Bld. Addition / Pilot  
Maine, Surgical Assoc.  
Heart

**CITY OF PORTLAND, MAINE  
DEVELOPMENT REVIEW APPLICATION  
PLANNING DEPARTMENT PROCESSING FORM  
Planning Copy**

**RESPONSE TO PLANNING STAFF REVIEW COMMENTS OF 4-6-05**

**RESPONSE TO PLANNING STAFF REVIEW COMMENTS RECEIVED 5-19-05**

Issue Date: 04-28-05  
 Drawn By: TH  
 PA / PE: PSC  
**A20.2**  
 Scale: As indicated

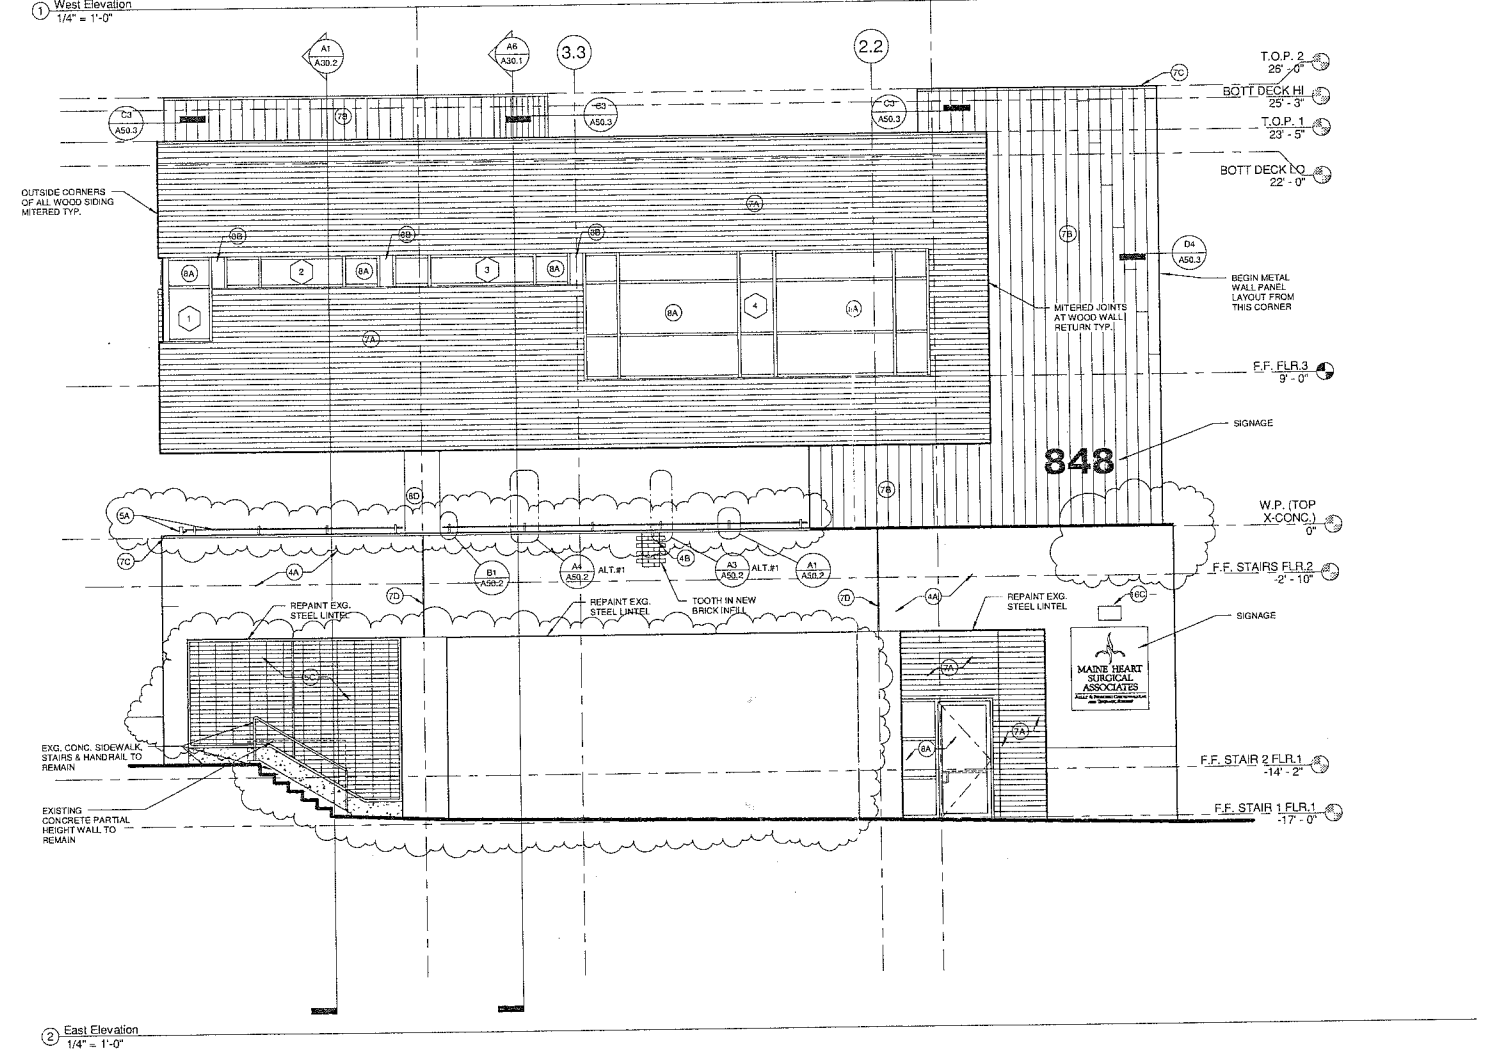
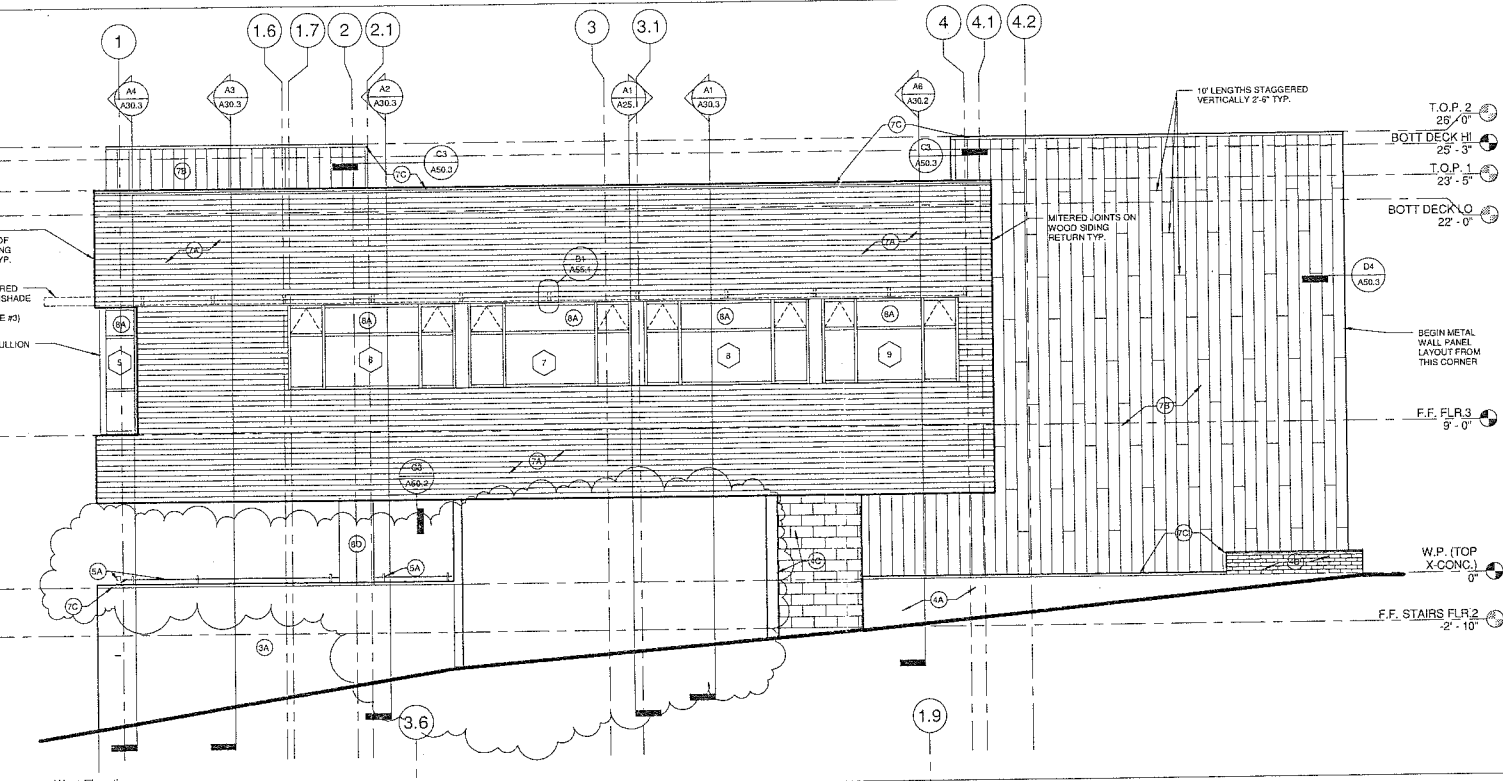
6. The **architectural uplighting** you have described for the building's upper facade and wall mounted street numbers must conform to the City's exterior lighting ordinance. Please provide catalog cuts of the proposed uplighting fixtures as well as surface photometrics to demonstrate conformance with the ordinance. Enclosed is a copy of the City's exterior lighting ordinance for your convenience.

encl: Drawing A20.2, Color Chart, Steel Panel sample, Hardiplank sample, C/S Custom Grilles product literature

Scale As indicated  
**A20.1**  
 Issue Date: 04-28-05  
 Drawn By: TH  
 PA / PE: PSC

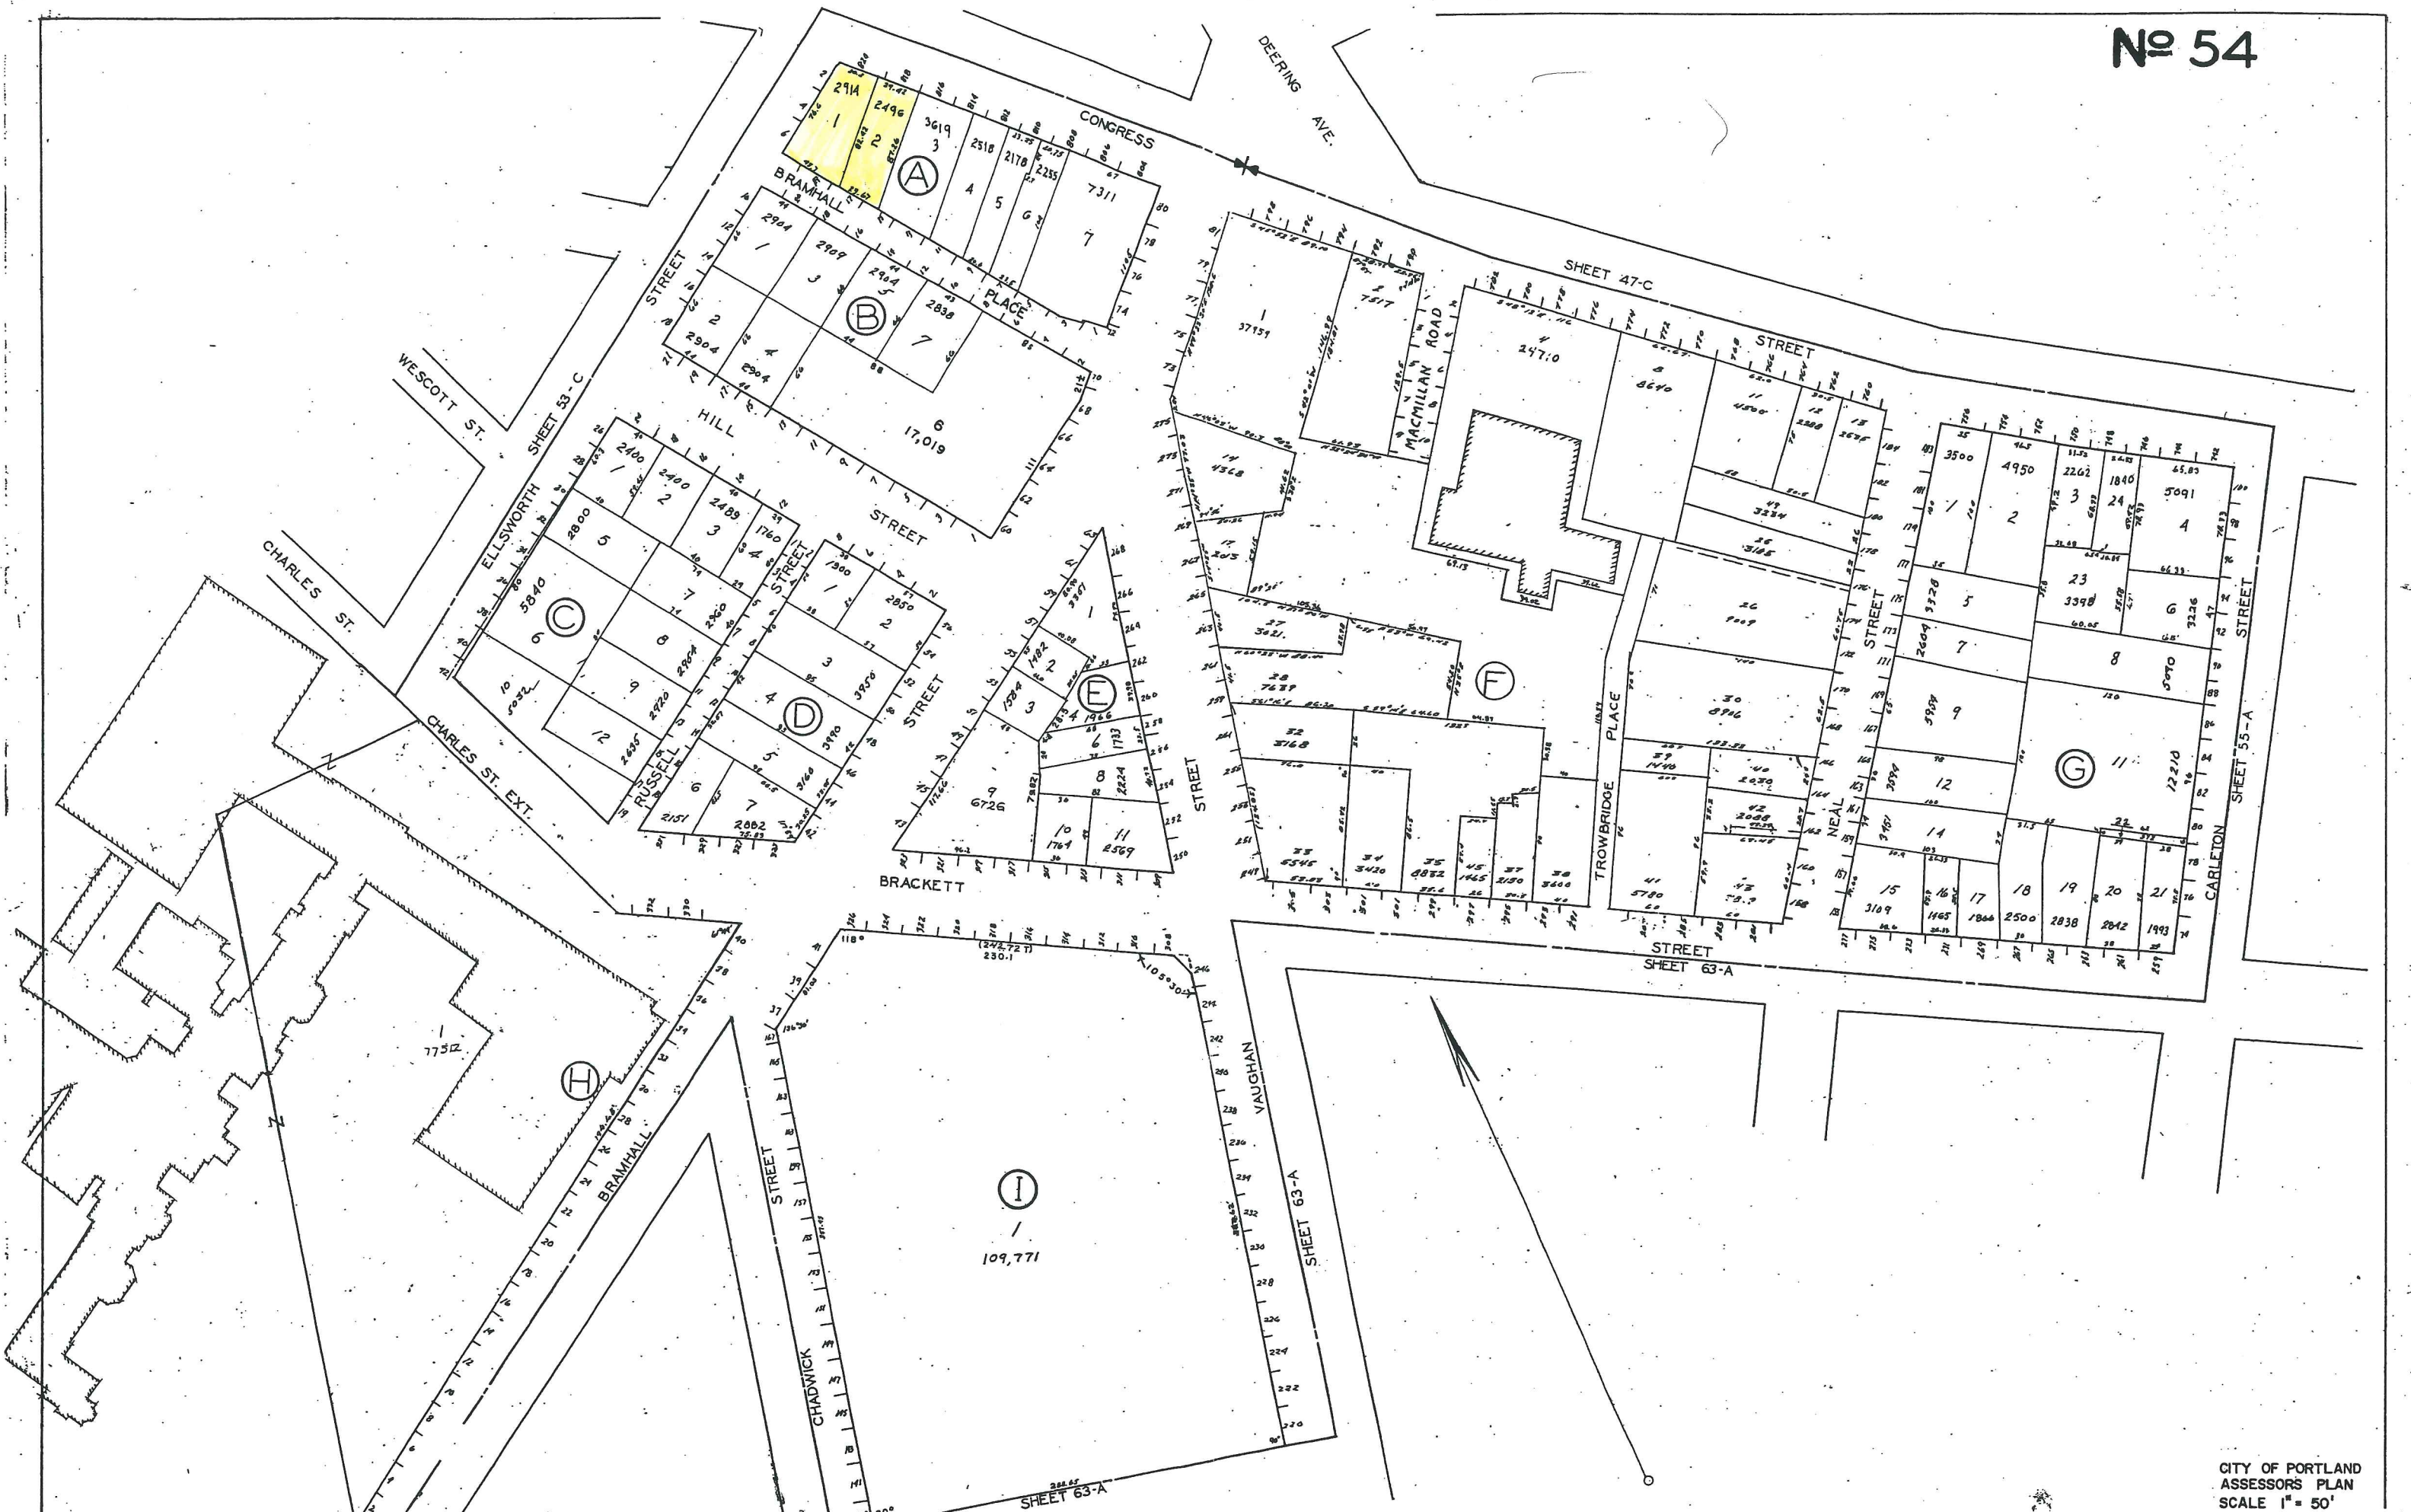
3. Please provide details/catalog cuts of the proposed **Congress Street security gate** at the garage entrance.
4. The long-term durability and maintainability proposed **cedar rain screen** is still of concern to staff. However, we understand that Harriman Associates has thoroughly

5. You have indicated that a number of design elements are, at this stage, considered **alternatives**, which may or may not be employed, depending on cost considerations. Please be advised that once approved, the building will be required to substantially conform to the proposed plan. Please present a final proposed plan indicating all architectural features proposed.

the building as well as the rolling grill and security screens at parking level 2. Currently the building elevations (A20.1 & A20.2) show both the rolling grills and security screens (dashed) as alternates so these would be deleted from the elevations. We acknowledge that the Staff at the Planning Division recommended that we add a canopy element that would complement the sunscreen on the rear of the building. However due to the deletion of the alternates due to cost, a front canopy is no longer an option.

4. As a result of value engineering to reduce cost, the cedar siding, as well as the rainscreen, will be replaced by a traditional horizontal wood siding or painted Hardi-Plank siding. The zinc panels will be replaced by painted steel panels.
